City of Nedlands

Special Council Meeting 4 March 2021

1. Joint Development Assessment Panel Application for Mixed Use Development - comprising 22 multiple dwellings and office – No. 105 (Lot 544) Broadway, Nedlands
2. Any Available Responsible Authority Reports

Drawing No. **SK09** Rev. **K**

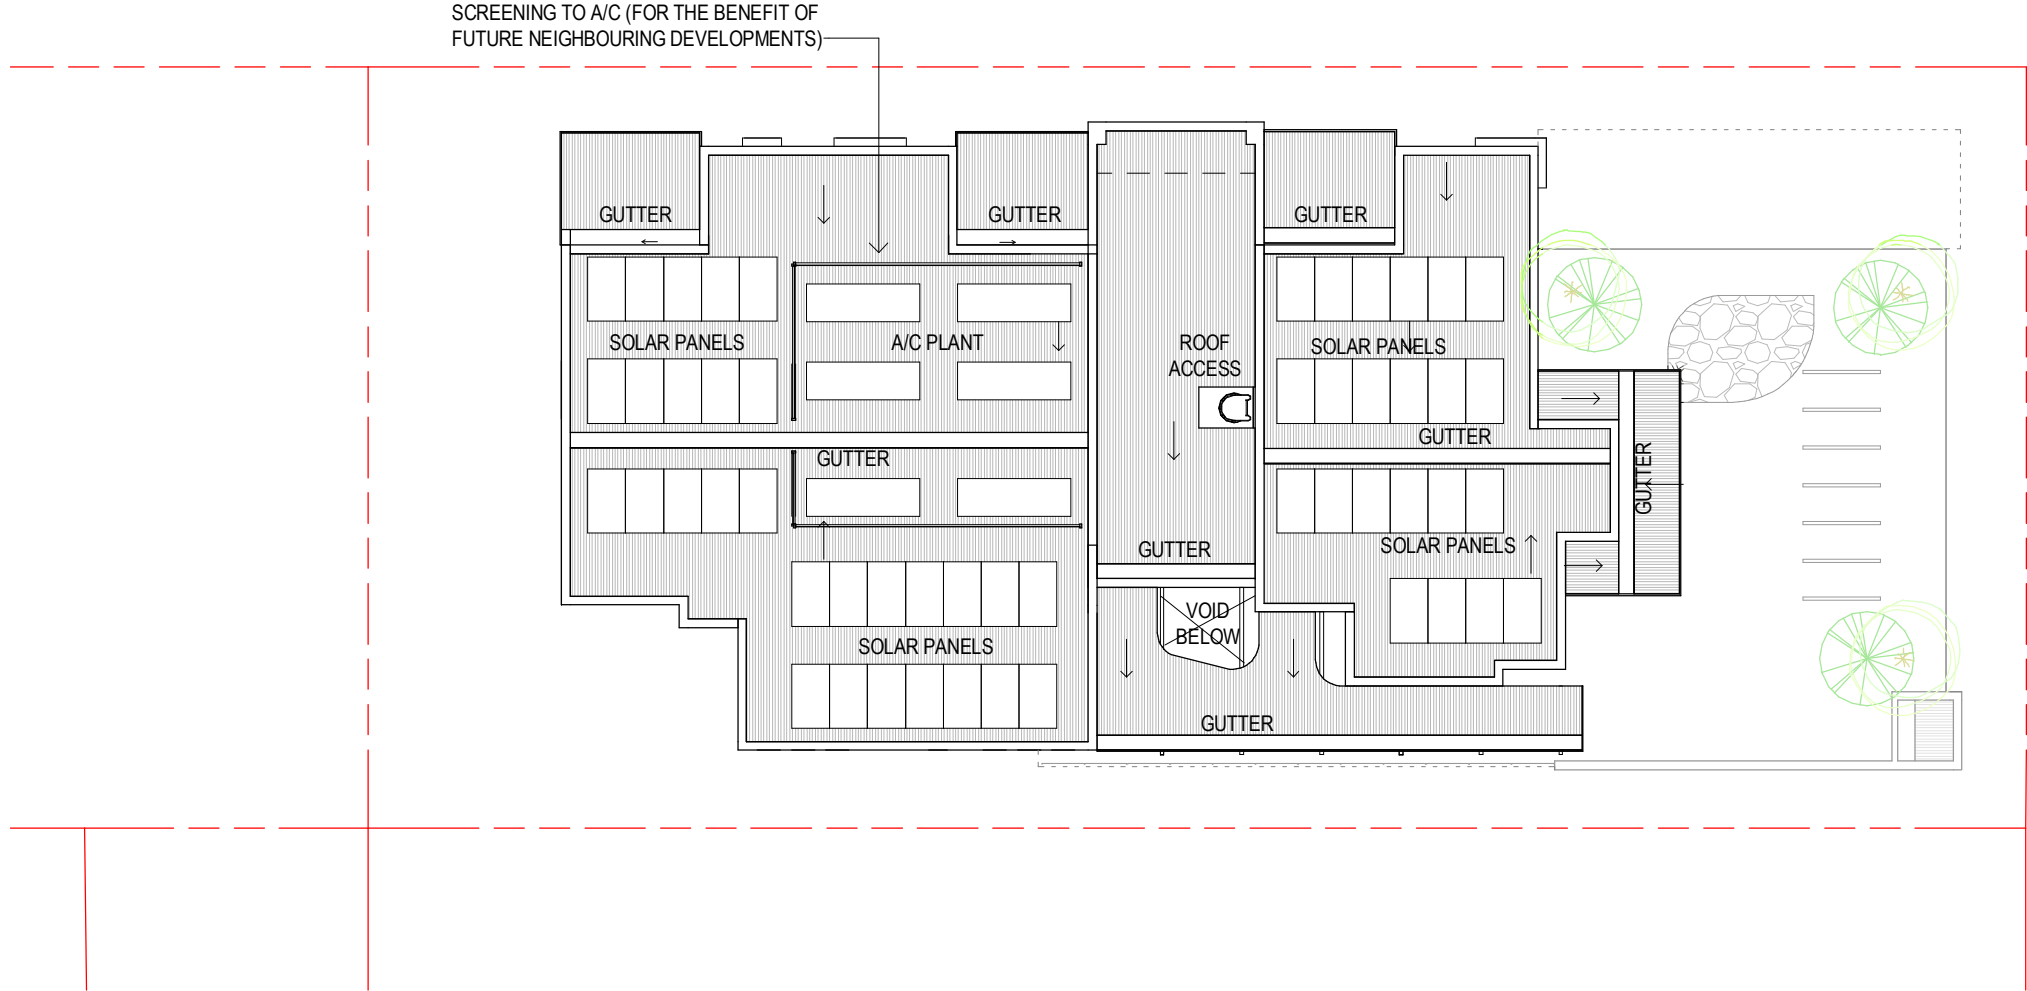
<p>Drawing SK09 has a note on the eastern edge stating 'glazing for safety' which points to a line inside the outer edge of the planter in this same vicinity. The same detail appears to continue around the northern side of the building. This detail would appear to hinder ease of access and hence the ability to maintain this planting.</p> <p>Overall, the landscape plans propose a reasonable range of plant species for each of the various physical locations with their respective microclimatic conditions.</p> <p>The provision of the 'Residents Terrace' is a significant positive attribute of the proposal. Though the narrow strip of landscape on the southern side of the walkway leading to this area may be problematic due to its narrowness for most of its length plus the fact that it will be in shade for much of the time and as such it will be difficult to maintain and prone to failure.</p> <p>Further explanation should be provided with regard to the chosen rationale for what appears to be the public art as shown on the Elizabeth Street elevation. No consideration seems to have been given as to the implications regarding the angle of the street and its impact upon the 'artwork', i.e., it is not 'purpose commissioned' and as such it is not effectively integrated into the architectural expression.</p> <p>Notwithstanding the issues raised above, some of which could be conditioned, with one exception, the quality of the landscape is considered to be of a sufficiently high standard to warrant supporting the proposal. That one exception relates to item 2g above which is really a site planning issue, i.e., the close proximity of the main landscape area on the first floor in relation to compromising the privacy of Unit 1.</p>

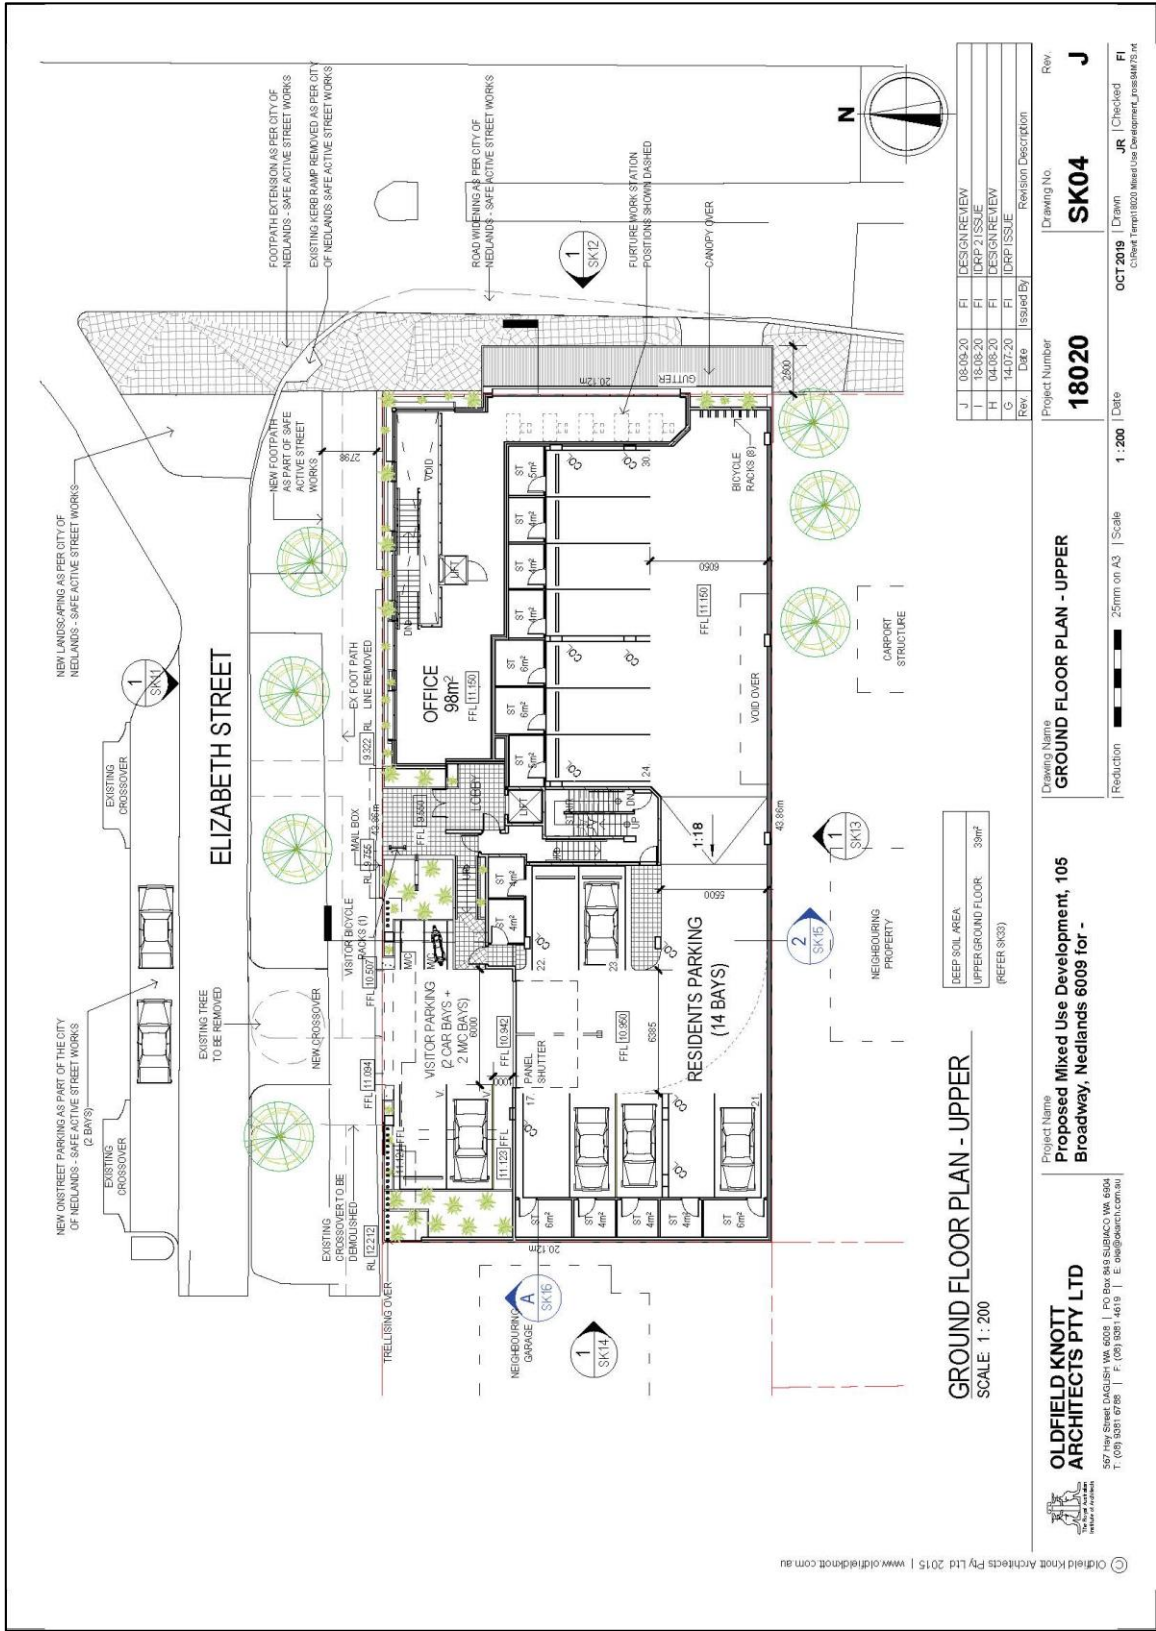
- Proposed peak hour traffic numbers do not match the trip distribution shown in Figure 2. An Update is required.
- Provide an explanation for the proposed traffic distribution. The Daily distribution indicates the applicant did not consider the fact that two levels are not connected, and Broadway frontage is left in left out.
- Elizabeth Street is Safe Active Street that is designed to encourage a low number of traffic flows (below 1,000 VPD at present to allow people to get used to the concept and up to 1,500 VPD in the future). The City's traffic counts from 2019 indicate Elizabeth Street carries 880 vehicles per day, indicating it is already very close to its target vehicle numbers.

Figure 2 updated – Refer **Attachment 6** – updated TIS. Updated trip distribution included in the updated TIS. The trip distribution applied in the TIS takes into account crossover formats and road network functionality as well as location of the site in wider context.
